Smart Motorways Programme

M4 J3 – J12

Package 2 (J3 to 8/9) Designer's Response to Road Safety
Audit (Stage 2)

Document Number: HA514451-CHHJ-GEN-SZ_ZZZZZZZZ_Z-RP-ZZ-0004

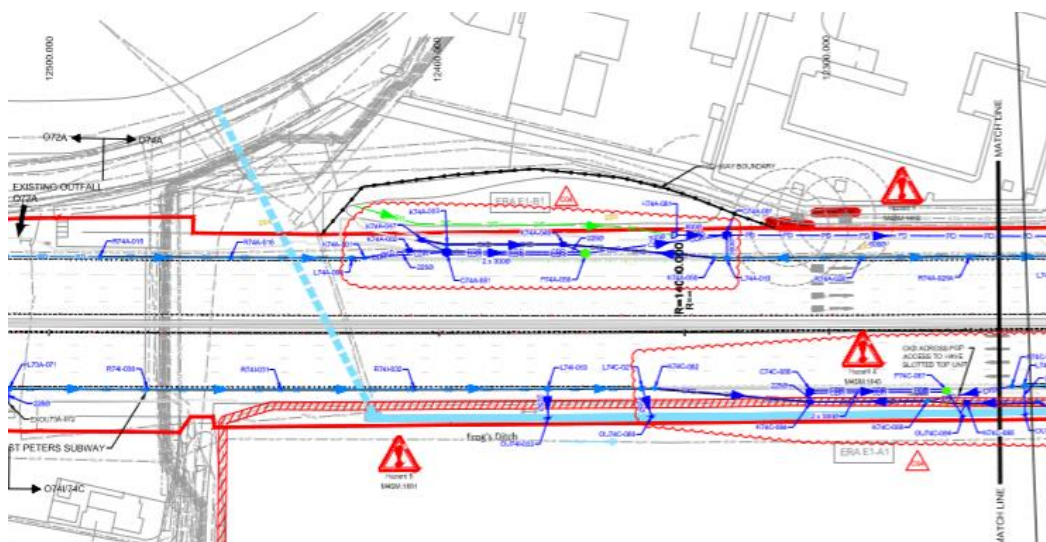
Summary: Location of EA spillage containment may lead to poor skid resistance of vehicles making an emergency stop due to uneven or slippery surface leading to injury

Throughout the scheme, spillage containments are positioned within EAs. An example of this is at the proposed eastbound EA E3-B1 located at chainage 18550. The details of these containment facilities are not clear and may pose a risk should they cause an uneven surface or impact on the skid resistance of vehicles making an emergency stop within these areas. This may lead to injury through loss of control collisions.

It is recommended that the EA spillage containment is appropriately sited to ensure it does not impact on vehicles entering the emergency areas.

Designer accepts the RSA problem and recommendation made by the RSA team.

All chamber access covers located in the EAs shall have E600 cover and frames with higher skid resistance, as stated in Appendix 5/1.

Extract from drawing HA514451-CHHJ-HDG-S2_DGZZZZZZZ_Z-DR-CD-5165 Rev C04

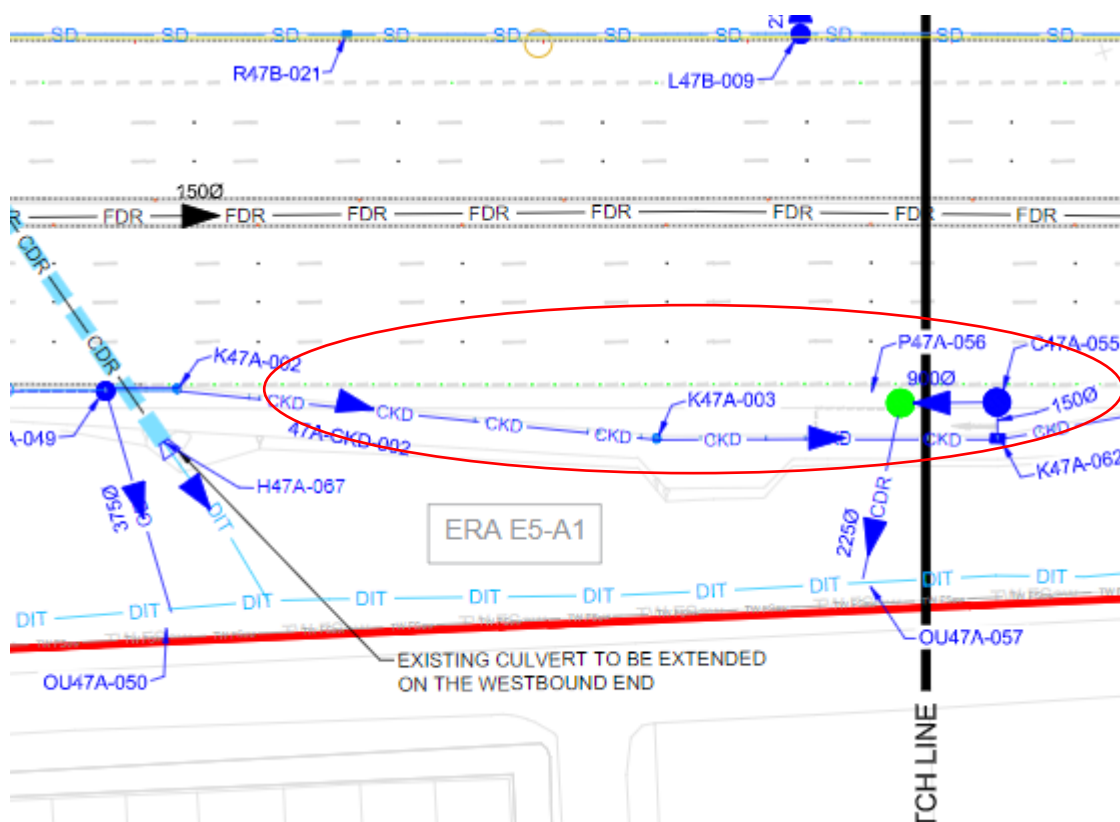
Summary: Lack of drainage provision

No drainage provision along the central reservation is indicated between chainages 12625 and 12255 although a filter drain is shown immediately up and down stream of this location. Without drainage through this section there is a risk of water standing in the carriageway, increasing the risk of loss of control type collisions.

It is recommended that drainage provision along the central reservation is continued through this section.

Designer disagrees with the RSA problem and recommendation raised.

The carriageway at this location is balanced therefore drainage collection systems are proposed on the verges only. Site investigation during construction of the concrete barrier had confirmed there are no existing filter drains or fin drains located at the central reserve.

Extract from drawing HA514451-CHHJ-HDG-S2_DGZZZZZZZZ_Z-DR-CD-5121 Rev C02

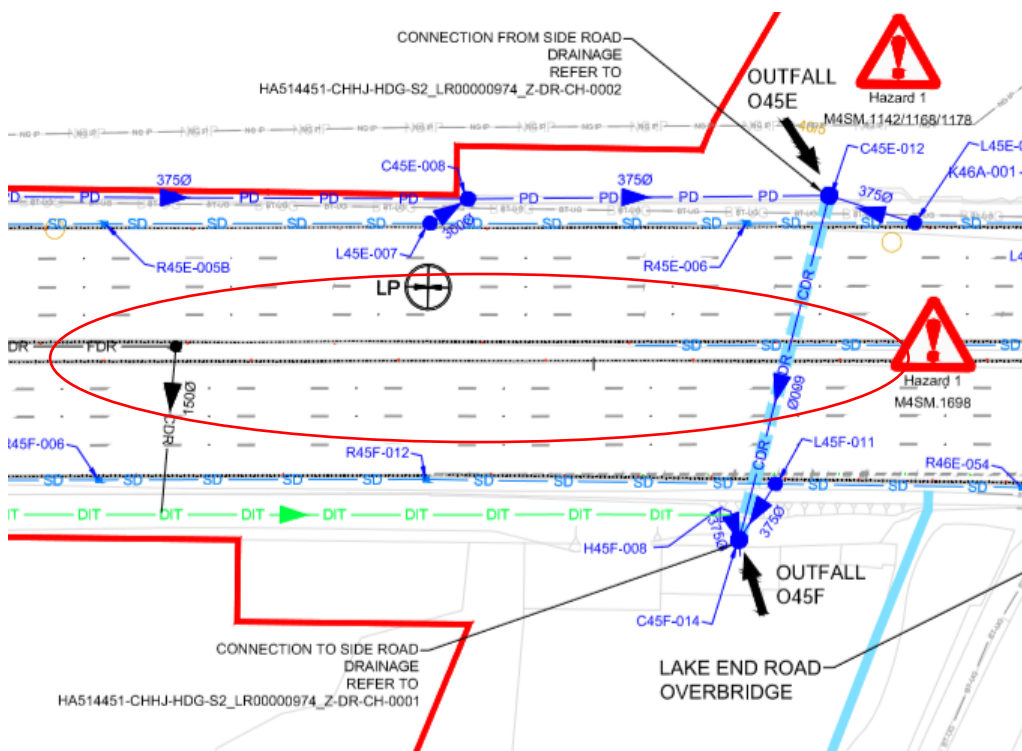
Summary: Lack of drainage provision

EA E5-A1 only has combined kerb drainage at the rear of the EA compared to other EAs where there is also a carrier drain provided along the interface with lane 1, for example E5-B1. It is not clear from the provided drawings if the cross section profile of the EA requires drainage along the interface with lane 1. A lack of drainage could result in water standing within the EA and adjacent carriageway increasing the risk of loss of control collisions, particularly at a location where vehicles could be braking.

It is recommended that drainage provision is provided along the front face of EAs where required.

Designer disagrees with the RSA problem and recommendation raised.

It is the design strategy for the combined kerb and drainage system to drain the width of the carriageways, where the road falls towards the verge. EA E5-B1 has a different layout because at that location the space constraint has meant that the piped ditch needed to route through the EA build-out rather than conventionally at the back of the EA.

Extract from drawing HRR-S2_ML000000_Z-DR-CH-4014 Rev C02

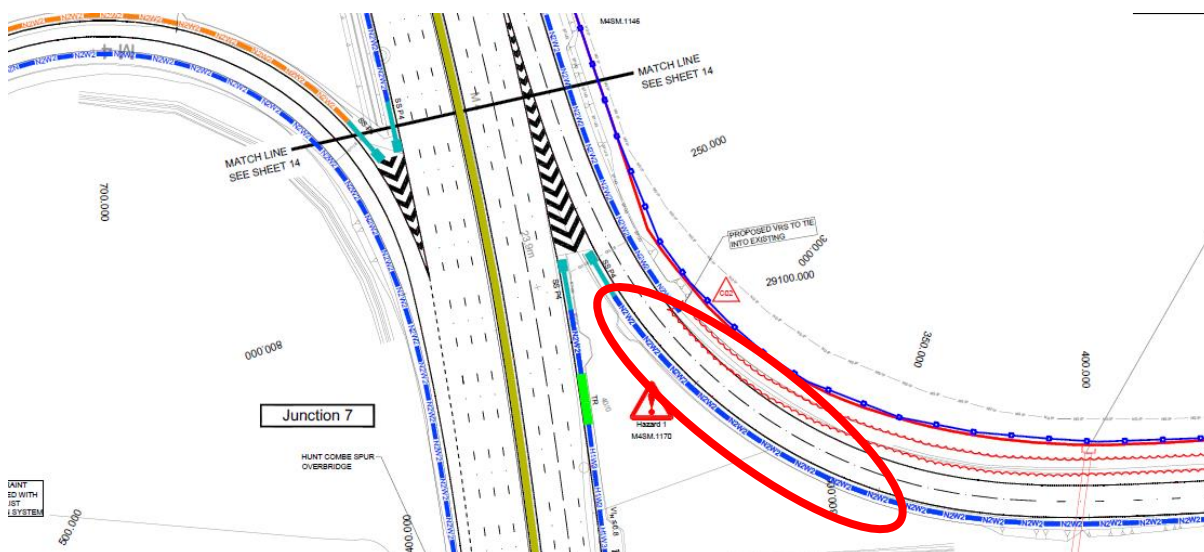
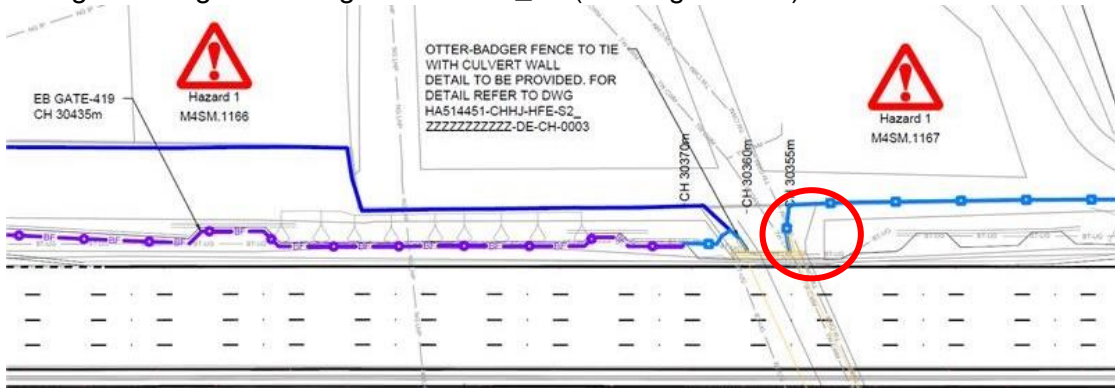
Summary: Risk of increased injuries to motorcyclists

Designer accepts the RSA problem and recommendation made by the RSA team.

Change will be made to Series 400 schedule HA514451-CHHJ-HRR-SZ_MLZZZZZZ_Z-SH-CH-0001 to incorporate adequate motorcycle protection with left-hand bends on J7 EB diverge offside slip road and J7 WB merge offside slip road.

- ‘Slough Trading Estate’ sign PS-B-41/2_80 (chainage 30350)

Extract from drawing HFE-S2_ZZ000000_Z-DR-CH-3029 Rev C02

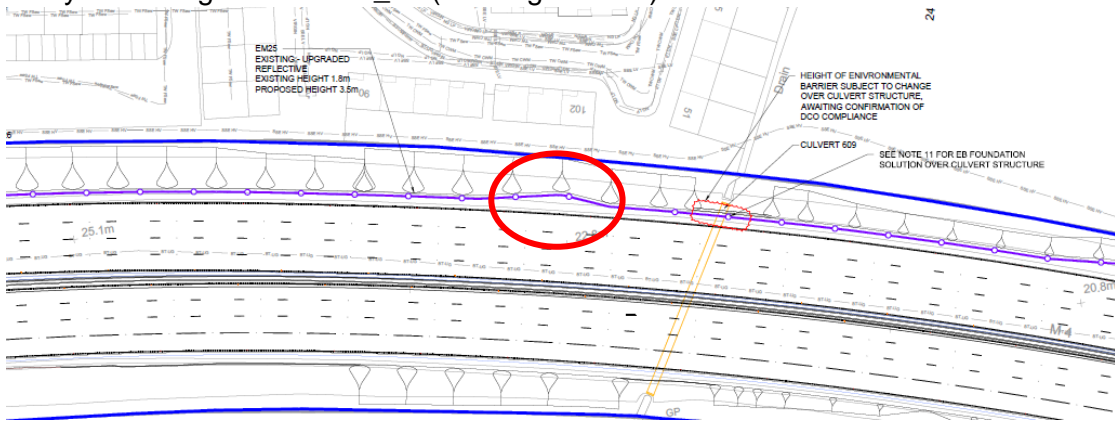
- EA 300 yard sign PS-B-41/7_55 (chainage 30800)
- Lane sign PS-B-37/0_65 (chainage 26130)
- 300 yard EA sign PS-B-35/7_06 (chainage 24750)

Extract from drawing CHHJ-HRR-S2_ML000000_Z-DR-CH-4065 Rev C02

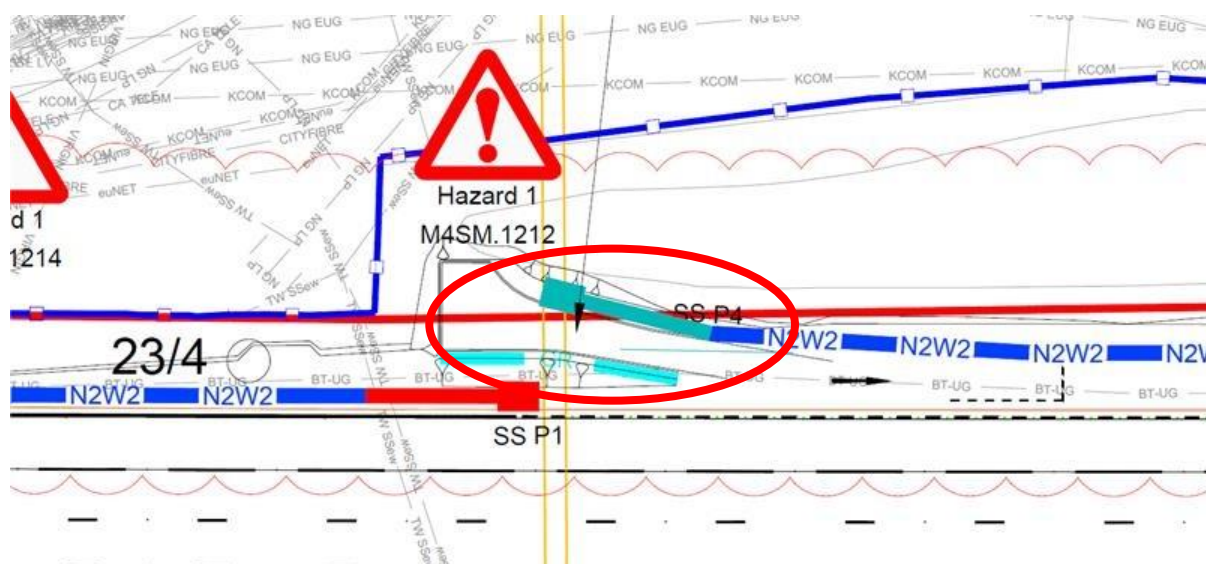
Summary: Extent of mainline RRS may lead to vehicles striking infrastructure or users of the EA

The restraint system drawings detail arrangements at some of the EAs, such as EA E1-B1, where the extent of the mainline RRS does not protect the raised platform, observation area or associated infrastructure (such as guard railing). This layout could also result in vehicles being retained by the RRS being directed into the EA, where vehicles, drivers and passengers could be located. This arrangement could increase the severity of a loss of control collision and result in a secondary incident involving users of the POP or EA.

This detail is referenced in drawing HA514451-CHHJ-HRR-S2_ML000000_Z-DR-CH-4065.

Extract from drawing HA514451-CHHJ-HPV-S2_ML000000_Z-DR-CH-7009 Rev C01

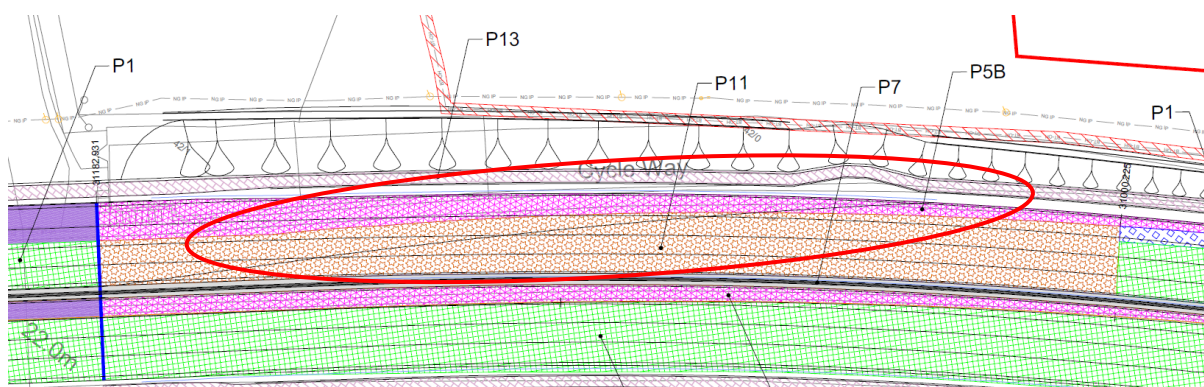
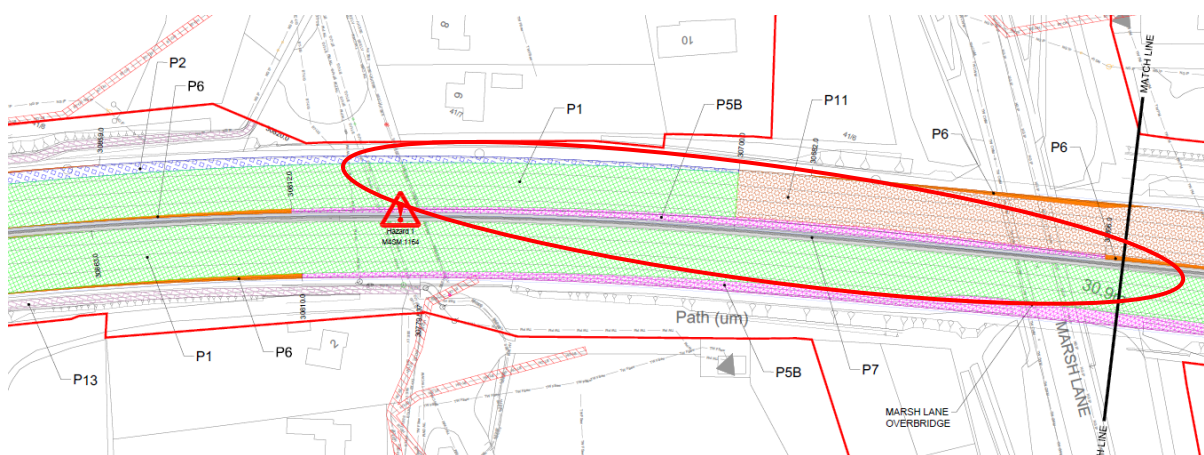
Throughout the scheme there are different surfacing arrangements. Where these different surfacing arrangements meet, the drawings provided indicate that both longitudinal and perpendicular surface course joints may be present within the lane extents and in wheel tracks. Examples of where this occur include chainages 31200, 30850, 29950, 28450, at various locations between 27200 and 26500, and around 14600.

The presence of longitudinal and perpendicular surface course joints in wheel tracks increases the potential for joints to fail over time. This can reduce the quality of the surface, effect vehicles under braking conditions and may hold standing water, increasing the risk of loss of control collisions.

Extract from drawing CHHJ-HSN-S2_ZZZZZZZ_Z-DR-CH-12017 Rev C01

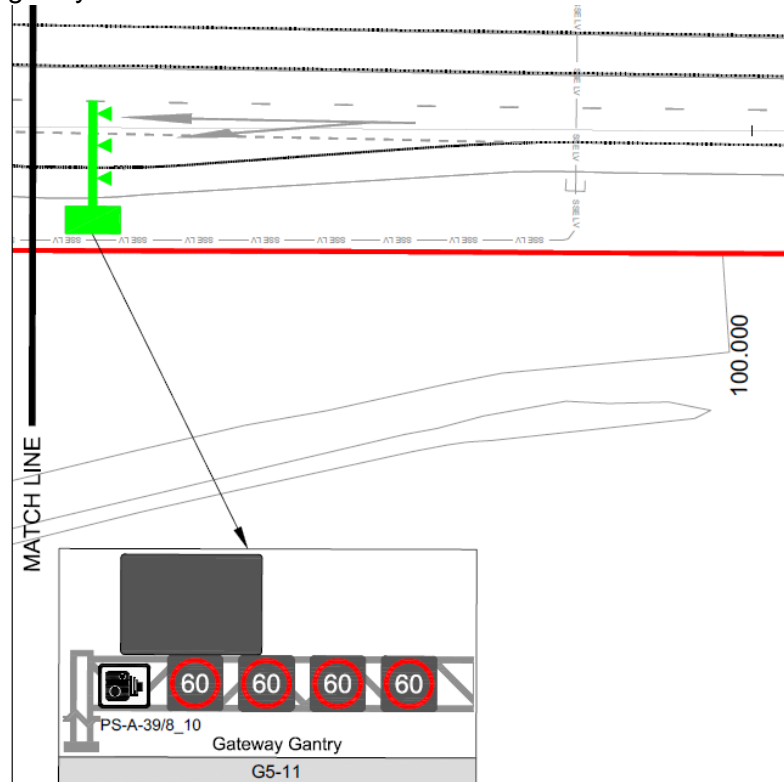
- gantry G5-11 north of Junction 7

Designer accepts the RSA problem and recommendation made by the RSA team.

All gantry layouts have been designed and updated in accordance with Traffic Signs Manual Chapter 7. Specifically, Cl.9.1.4 identifies that 'the downward pointing arrows on the lane drop sign should be centred over the traffic lanes to which they apply'. The 2D layout plans are only indicative to confirm chainage and orientation. The lane arrows of all gantry mounted direction signs are checked prior to fabrication as part of the approval of Design Submissions.

Extract from drawing CHHJ-HSN-S2_///////_Z-DR-CH-12050 Rev C01

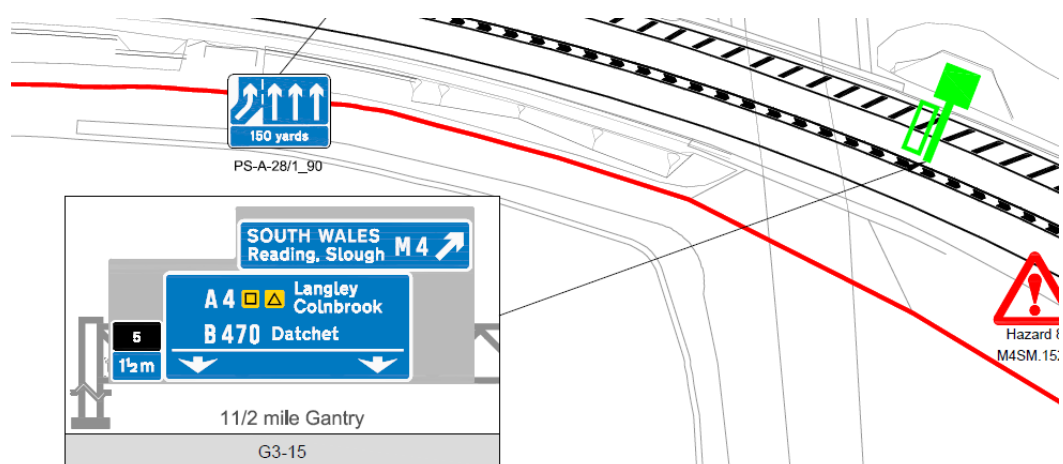
- gantry G4-17 (chainage 25450)
- gantry G4-07 (chainage 22500)
- gantry G3-12 (chainage 19370)
- gantry G3-15 (chainage 17120)

Extract from drawing HGN-S2_ML000000_Z-DR-CH-1013 Rev C01

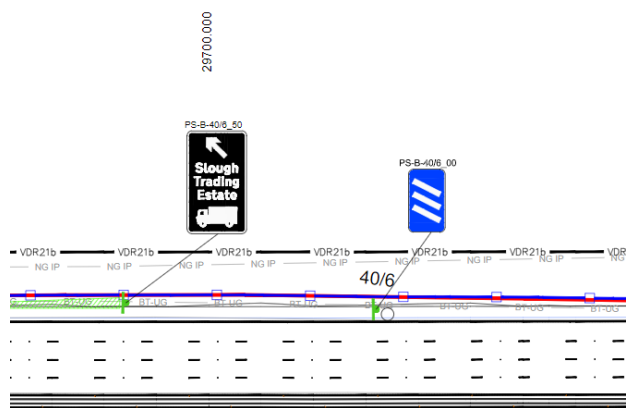
- Route marker sign PS-B-44/3_80 (chainage 33450)
- 300 yard countdown sign PS-B-40/6_00 (chainage 29670)

Extract from drawing HGN-S2_ML000000_Z-DR-CH-1043 Rev C01

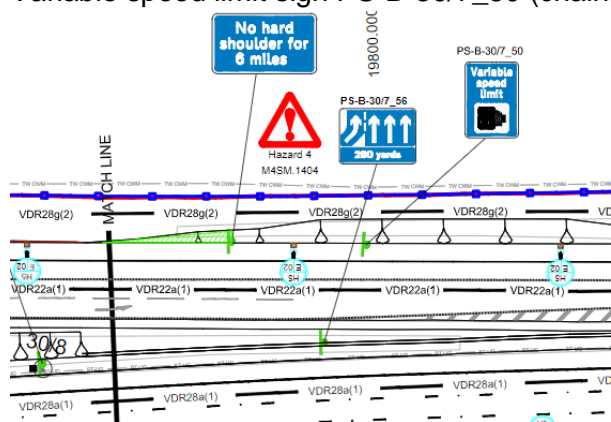
- Variable speed limit and No hard shoulder signs PS-B-39/8_32A & B (chainage 28900)
- Variable speed limit sign PS-B-30/7_50 (chainage 19800)

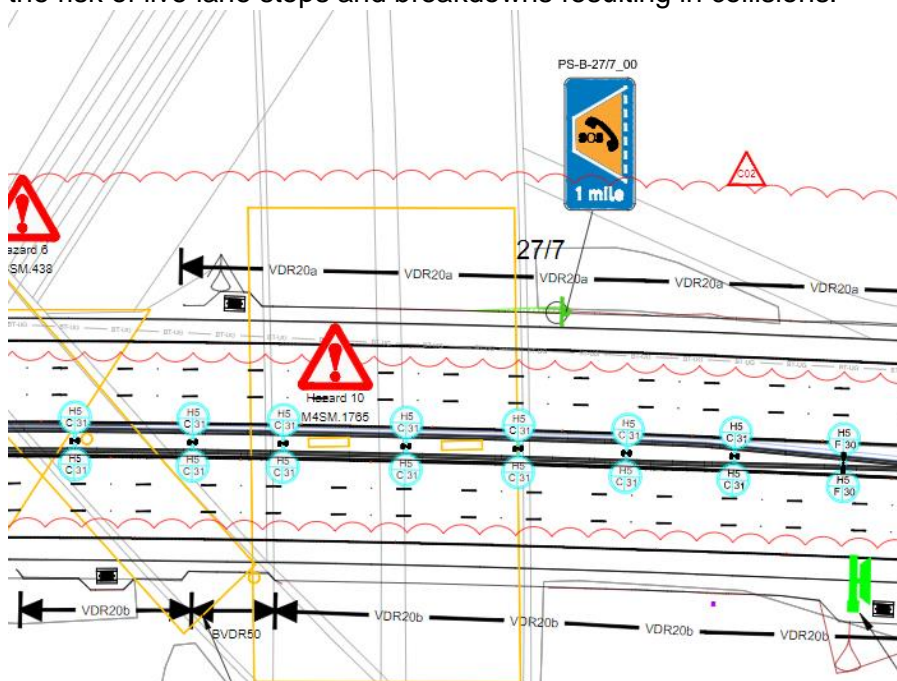
Location: Eastbound carriageway (Drawing HA514451-HGN-S2_ML000000_Z-DR-CH-1065 C02 Sheet 65 of 71 chainage 12300)

Designer disagrees with auditor recommendation.

A 1 mile Advanced Direction Sign cannot be provided on the approach to J3 eastbound due to the proximity of J4. The design has been agreed as the best-case solution considering the close proximity of the junctions

Extract from drawing HA514451- HGN-S2_ML000000_Z-DR-CH-1051

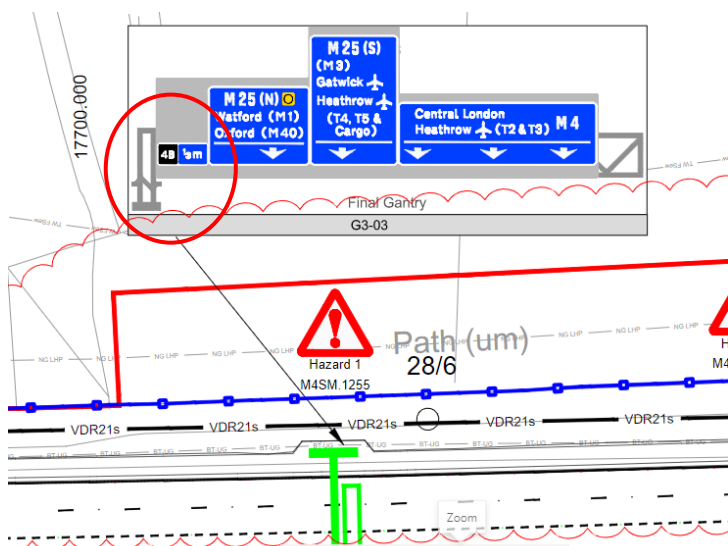
Location: Eastbound carriageway (Drawing HA514451-HGN-S2_ML000000_Z-DR-CH-1051 C02 Sheet 51 of 71 chainage 16700)

PS-B-27/7_00 to be relocated east within the constraints of tolerances for ADS signs in IAN 149/17.

A 400yds EA final approach sign will be provided for E2-B1.

Traffic Signs schedule HA514451-CHHJ-GEN-SZ_ZZZZZZZZZ_Z-SH-ZK-1201 will be updated to reflect the change.

Extract from drawing HA514451- HGN-S2_ML000000_Z-DR-CH-1062 Rev C02

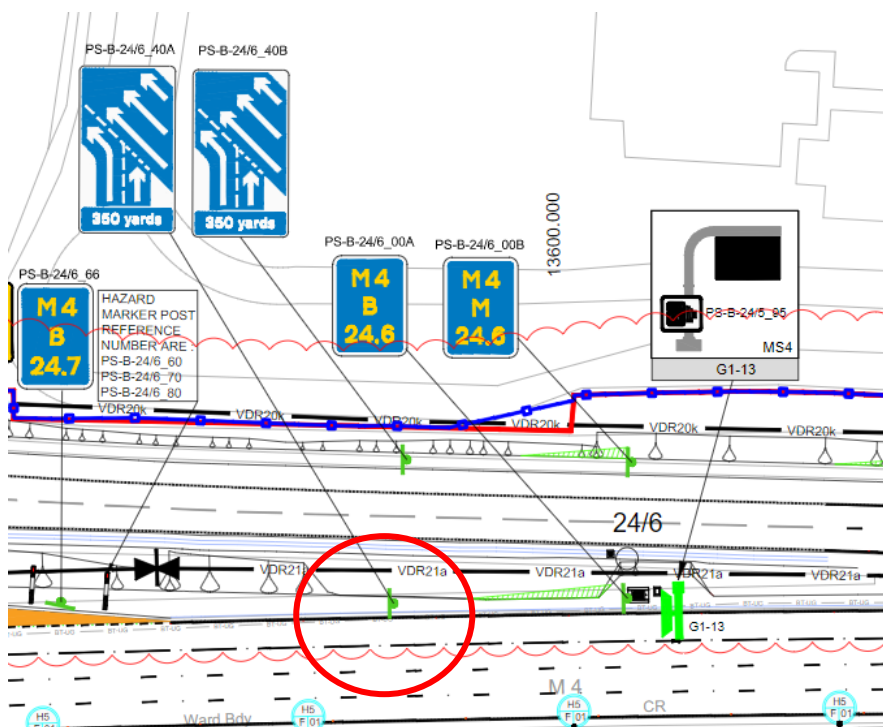
Summary: Position of sign may be misleading

The offside 350 yard side indicating the merge layout from the slip road is located significantly closer to the mainline carriageway than the slip road and drivers may assume it relates to the mainline. This could result in driver confusion and potentially late lane changing manoeuvres.

Offside 350-yard PS-B-24/6_40A is located just outside the RRS working width on the slip road and is shown as such in the 3D model. The indicative location on the drawing will be updated to reflect this.
